Product Change Notification / ASER-11ZWRV458

CCB 5295 Final Notice: Qualification of MTAI as a new final test site for selected AT17LVxxx device family available in 8L PDIP (.300in) package.

Pre and Post Change Summary

Tube Comparison – BQM and Pin 1 Orientation

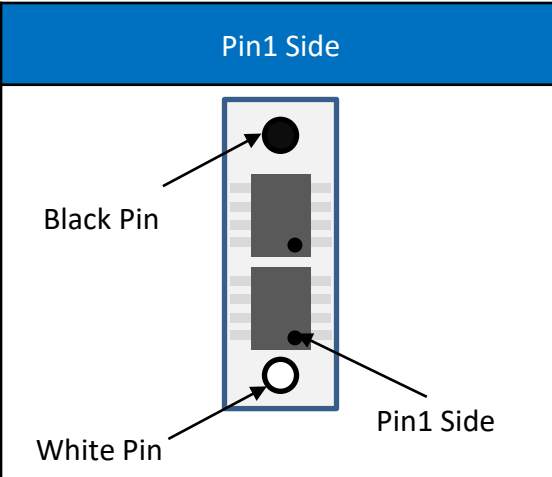
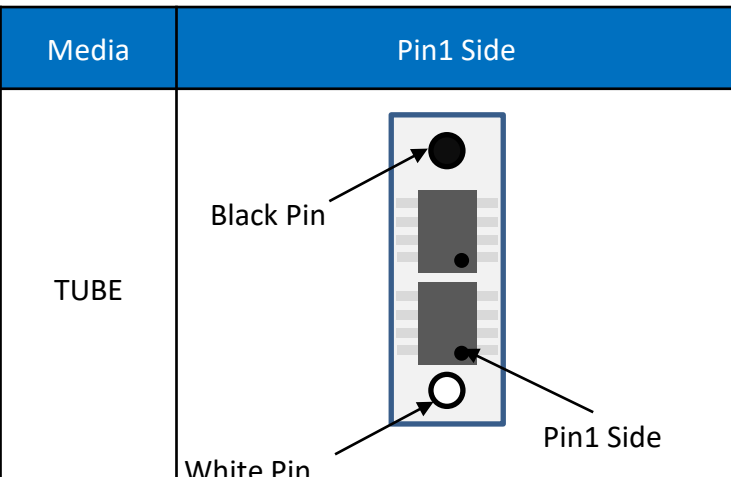
Pre Change					Post Change				
Media		Pin1 Side			Media		Pin1 Side		
TUBE					TUBE				
	Black Pin	White Pin	Pin1 Side	Pin1 Side		Black Pin	White Pin	Pin1 Side	Pin1 Side
Media	Unit per Tube	Tube per Bag	Unit per Bag	Pin#1 Orientation	Media	Unit per Tube	Tube per Bag	Unit per Bag	Pin#1 Orientation
TUBE	50	50	2500	Toward White Pin	TUBE	50	40	2000	Toward White Pin

Tube Comparison

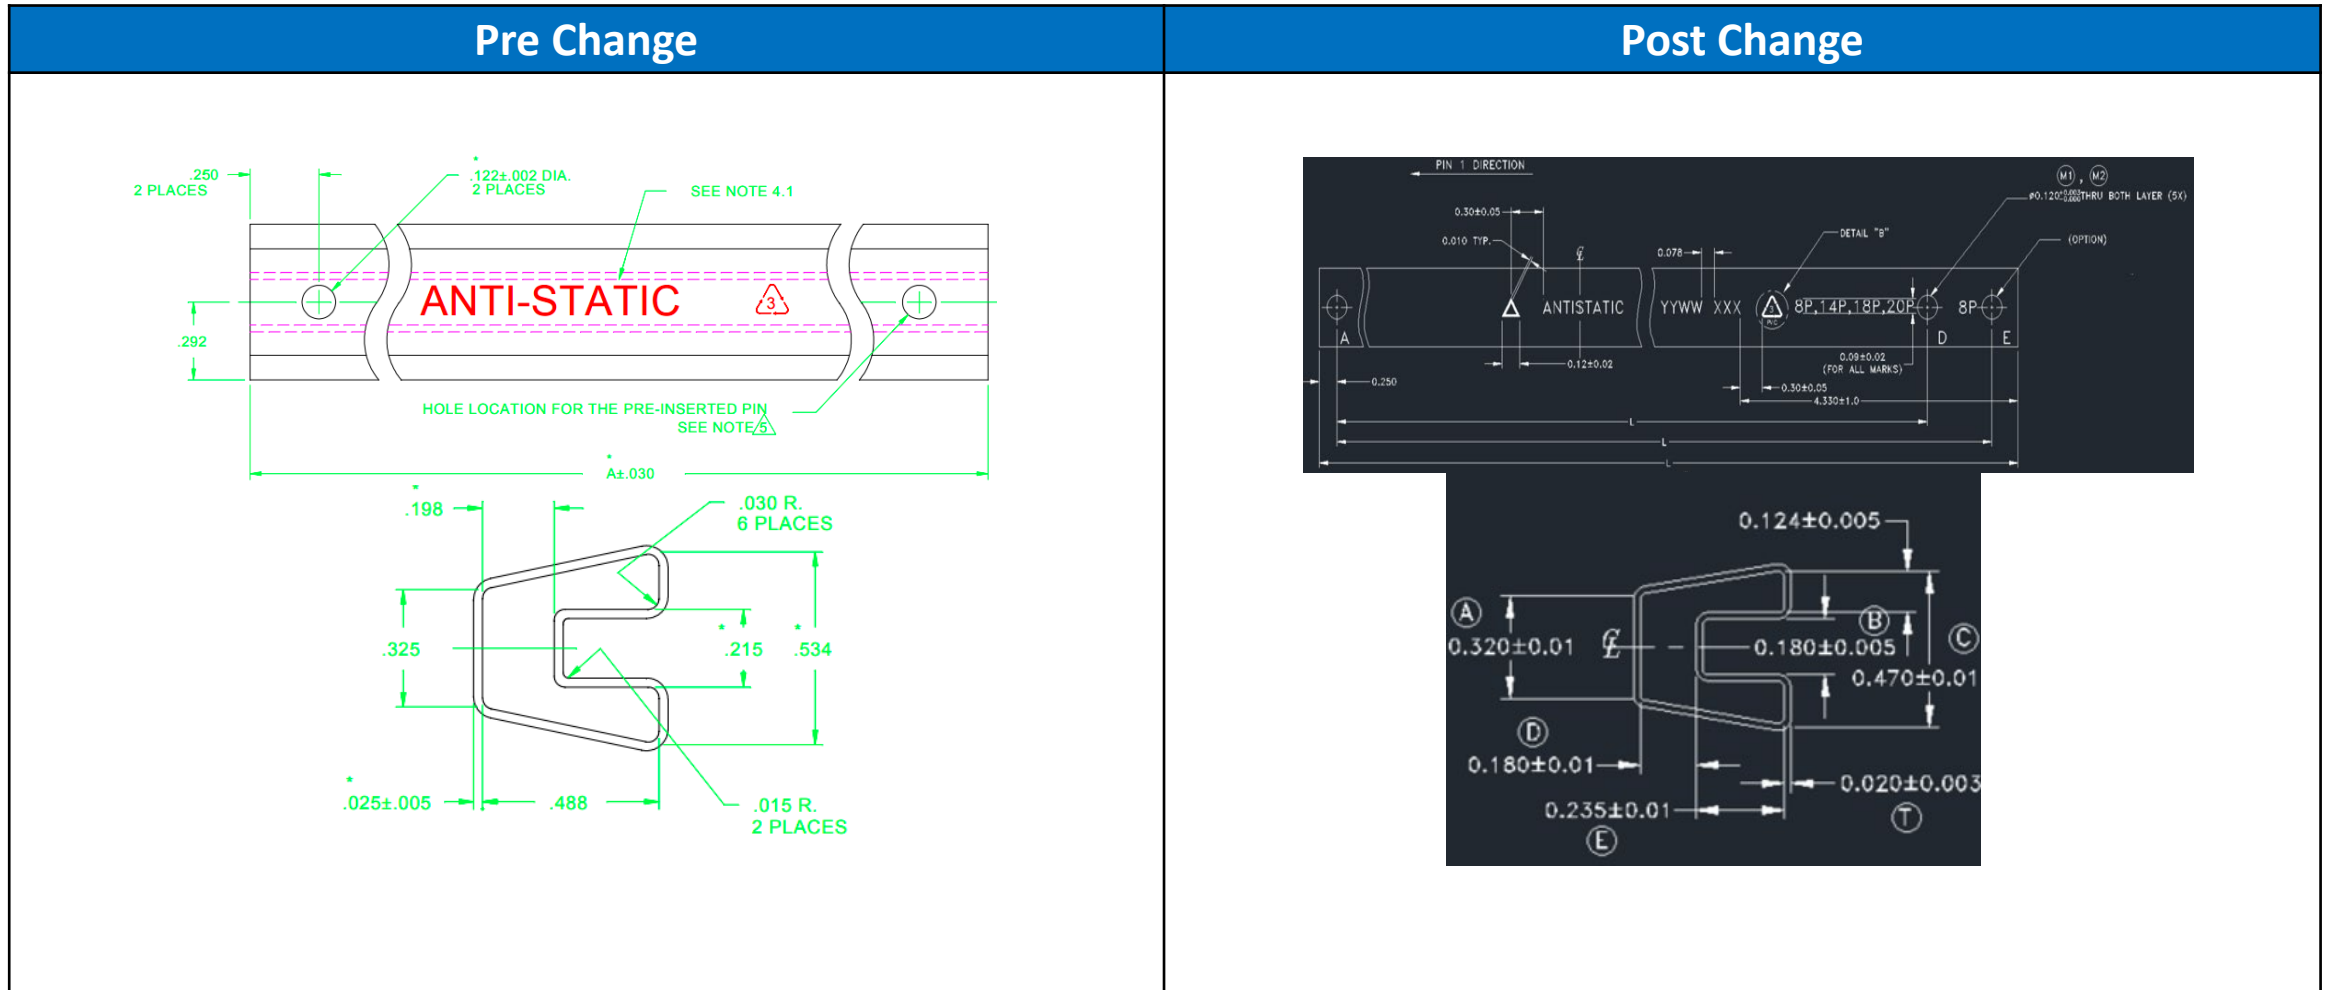
Scan&Pack Plant	Tube From	Tube Length (inch)	Center Hole A to Center Hole D (inch)	A (inch)	B (inch)	C (inch)	D (inch)	E (inch)	T (inch)	Color
ATP7	ANAP	20.00 +/-0.030	19.50 +/- 0.030	0.325 +/-0.010	0.215 +/-0.010	0.534 +/-0.010	0.198 +/-0.010	0.290 +/-0.010	0.025+/-0.005	Transparent Clear
MTAI	MMT	20.33 +/-0.025	19.28 +/- 0.050	0.320 +/-0.010	0.180 +/-0.005	0.470 +/-0.010	0.180 +/-0.010	0.235 +/-0.010	0.020 +/-0.003	Transparent Clear

Tube Comparison – Packing Method

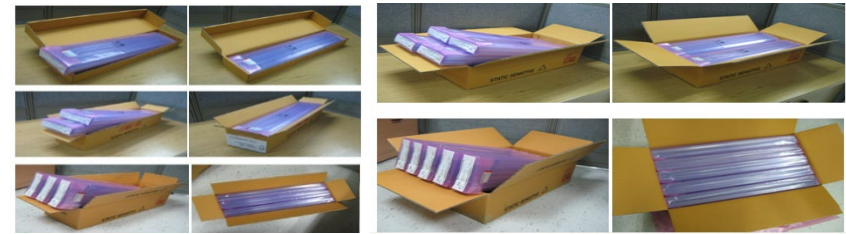
Bag - BAG STATIC SHIELD 12INCHX25INCH
 Inner Box - BOX, M02-010 12.9x56.5x8 BX

Bag type	Dimension
Antistatic Pink Gusset	140 x 760mm

(No inner box)
